MAIR300 Series adds a stainless steel filter mesh at the inlet

Design Change Notification

3. Change descriptions

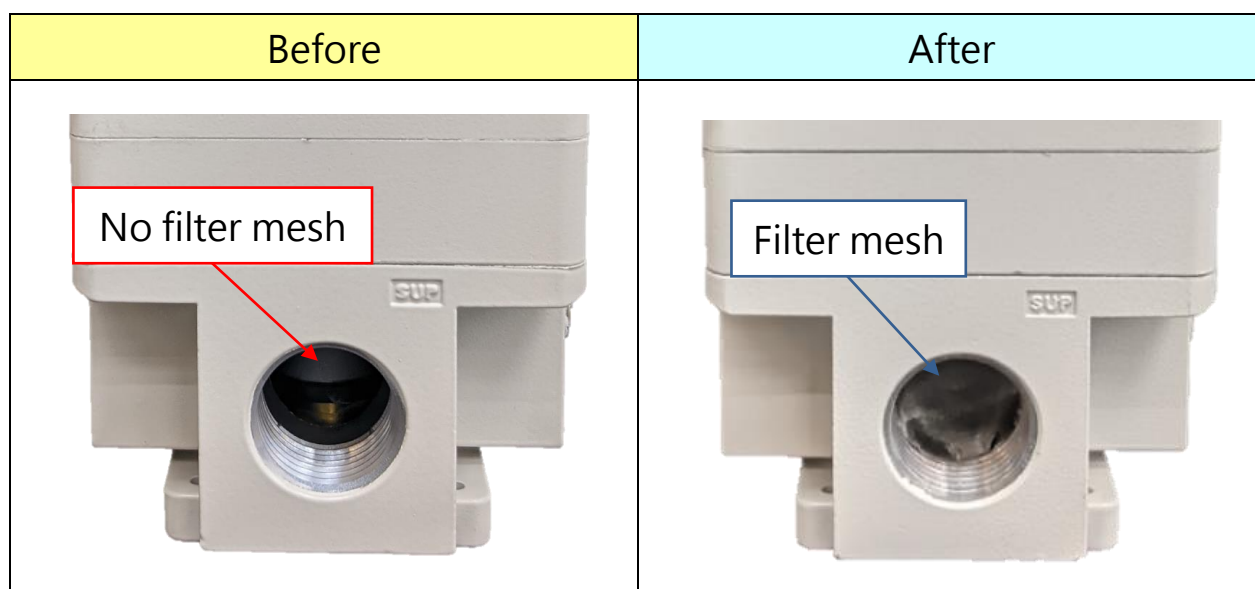
1. Model series
MAIR300 series
2. Design change reason
To prevent the abnormal performance from the sealant or pipeline impurities entering, MAIR300 series will add a stainless filter mesh at air inlet.
